## **Status Report of the work of Task Force on UN Regulation No. 46 (Devices for indirect vision).**

Submitted by the expert from Germany (leader of the Task Force on UN-R 46) on behalf of the Task Force on UN-R 46

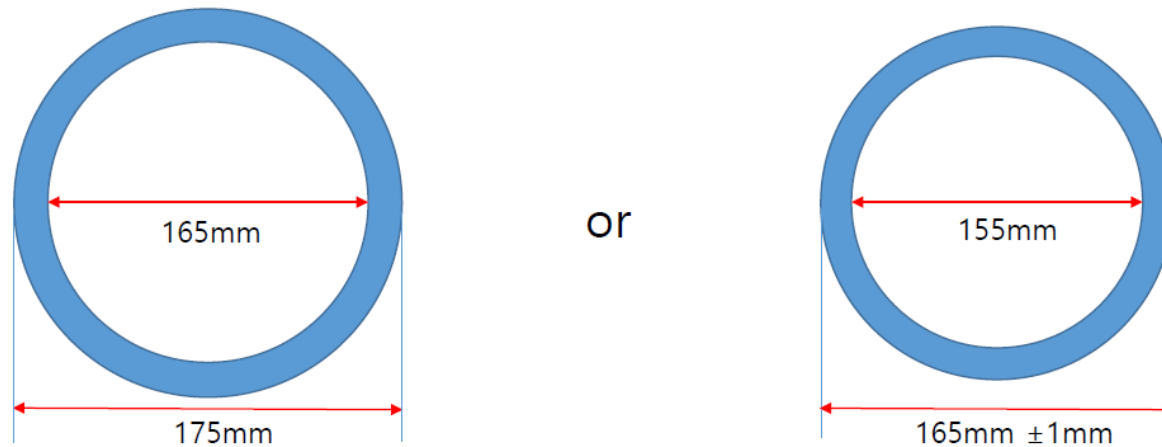
- (a) Proposal by the Republic of Korea to clarify the diameter of the impact test rig, document GRSG-125-24. This issue is handled in paragraph 6.3.2.1.1.  
*[Paragraph 6.3.2.1.1., amend to read:*  
"6.3.2.1.1. The test rig consists of a pendulum capable of swinging about two horizontal axes at right angles to each other, one of which is perpendicular to the plane containing the "release" trajectory of the pendulum.

[The end of the pendulum comprises a hammer formed by a rigid sphere with a diameter of  $165 \pm 1$  mm having [including/excluding] a  $5 \pm 1$  mm thick rubber covering of Shore A hardness 50 [to protect the rigid sphere [at the impact point]]].

Option 1:

[The end of the pendulum comprises a hammer formed by a rigid sphere with a diameter of ~~165~~  **$155 \pm 1$**  mm **and** a  $5 \pm 1$  mm thick rubber covering of Shore A hardness 50].

Option 2:

[The end of the pendulum comprises a hammer formed by a rigid sphere with a diameter of  $165 \pm 1$  mm **and** a  $5 \pm 1$  mm thick rubber covering of Shore A hardness 50.]

With regards to the diameter of the pendulum no conclusion was found. GRSG is asked for guidance, which diameter shall be used in the future.

**Figure 9.1**

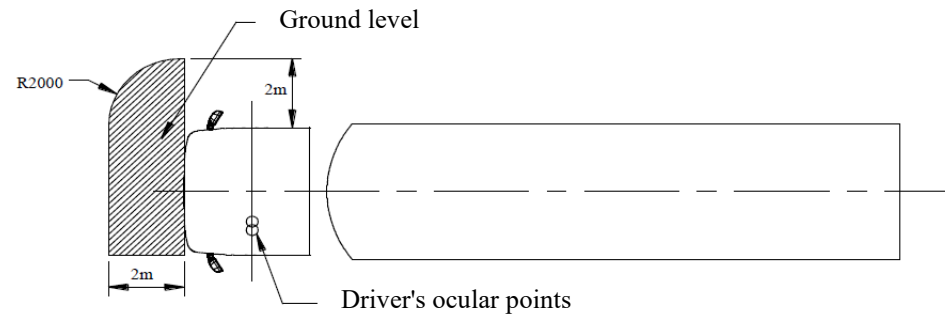
"15.2.4.6.1. The field of vision shall be such that the driver can see at least a flat horizontal portion of the road, which is **for side-steered vehicles** bounded by:

- (a) A transverse vertical plane through the outermost point of the front of the vehicle;
- (b) a transverse vertical plane 2,000 mm in front of the plane defined in (a);
- (c) a longitudinal vertical plane parallel to the longitudinal vertical median plane going through the outermost side of the vehicle at the driver's side; ~~and~~
- (d) a longitudinal vertical plane parallel to the longitudinal vertical median plane 2,000 mm outside the outermost side of the vehicle opposite to the driver's side; **and**
- (e) ~~The~~ **the** front of this field of vision opposite to the driver's side may be rounded off with a radius of 2,000 mm (see Figure 9.1).

Figure 9, renumber as Figure 9.1. and amend to read:

**Figure 9.2**

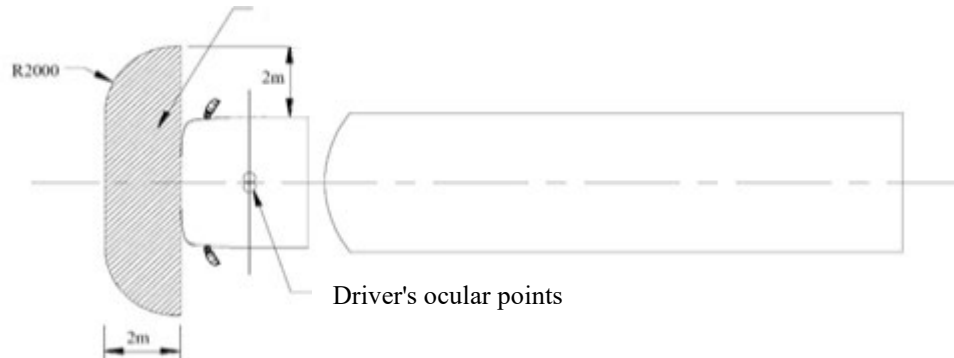
**The field of vision shall be such that the driver can see at least a flat horizontal portion of the road, which is for centre-steered vehicles bounded by:**

- (f) A transverse vertical plane through the outermost point of the front of the vehicle;**
- (g) a transverse vertical plane 2,000 mm in front of the plane defined in (a);**
- (h) a longitudinal vertical plane parallel to the longitudinal vertical median plane 2,000 mm outside the outermost side of both sides of the vehicle; and**
- (i) the front of this field of vision on both sides may be rounded off with a radius of 2,000 mm (see Figure 9.2).**

Insert a new figure 9.2., to read:

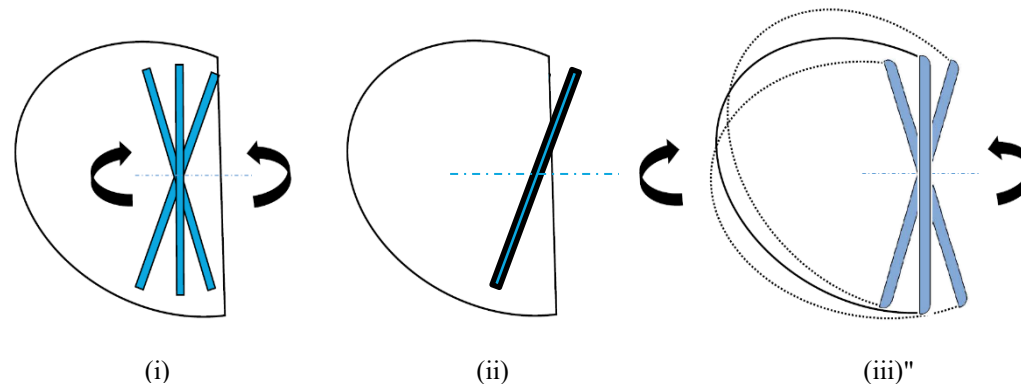
- (c) Proposal by OICA to introduce frameless outside mirrors, document ECE/TRANS/WP.29/GRSG/2023/16 as amended by GRSG-125-03-Rev.1. Additionally, the test procedure was clarified by amending paragraph 6.3.2.2.2. The Technical Service shall identify in consultation with the manufacturer the test positions for both directions.

**When the edge of the reflecting surface is enclosed in a protective housing, the radius of curvature "c" on the housing's perimeter shall be not less than 2.5 mm at all points and in all directions, figure below (i).**

**When ~~if~~ the reflecting surface projects beyond the protective housing in any adjustment position (figure below (ii)), the radius of curvature "c" on the edge of the projecting part shall be not less than 2.5 mm and the reflecting surface shall return into the protective housing under a force of 50 N applied to the point of greatest projection, relative to the protective housing, in a horizontal direction, approximately parallel to the longitudinal median plane of the vehicle.**

**When the edge of the reflecting surface is not enclosed by the protective housing independent from any adjustment position, the radius of curvature "c" on its perimeter shall be not less than 2.5 mm at all points and in all directions and shall apply to the edge of the projecting part, figure below (iii).**

**Figure 1**

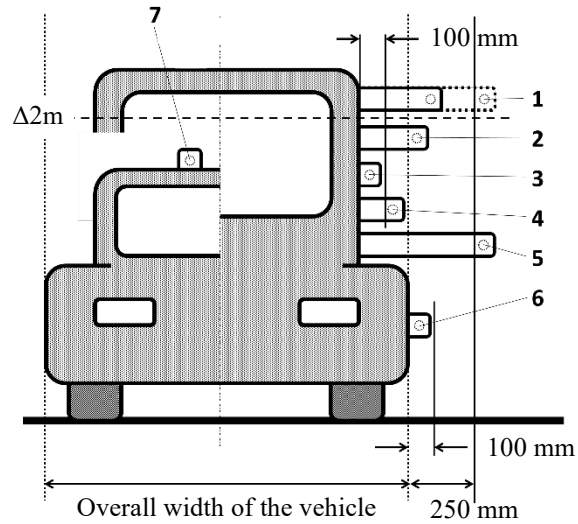
- (b) There could be different interpretations for the term “bodywork” in paragraph 6.3.2. as it is not defined. This could lead to different designs, for which it is unclear, if the pendulum test is needed. For clarification the text was amended and a new annex with a figure for further explanation was added.

Annex 9, Figure 1, amend to read:

PENDULUM IMPACT TEST	
<u>Device for indirect vision CLASS II-VII</u>	
1	NO TEST (15.2.2.6.)
2	COMPULSORY
3	NO TEST (6.3.2.b))
4	NO TEST (6.3.2.a))
5	not permitted (15.2.2.6.)
6	NO TEST (6.3.2.b))
<u>Camera of CLASS I (CMS)</u>	
7	NO TEST (6.3.2.b)

## "Annex 5

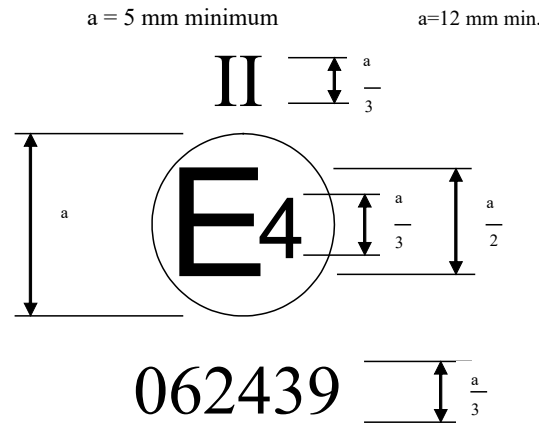
- (d) Finally, a new series of amendments is proposed and Annex 5 has to be updated.

*Annex 5*, amend to read:

The above approval mark affixed to a device for indirect vision indicates that the device is a main rear-view device, of Class II, which has been approved in the Netherlands (E 4) pursuant to Regulation No. 46 and under approval number 062439. The first two digits of the approval number indicate that Regulation No. 46 already included the 06 series of amendments when the approval was granted.
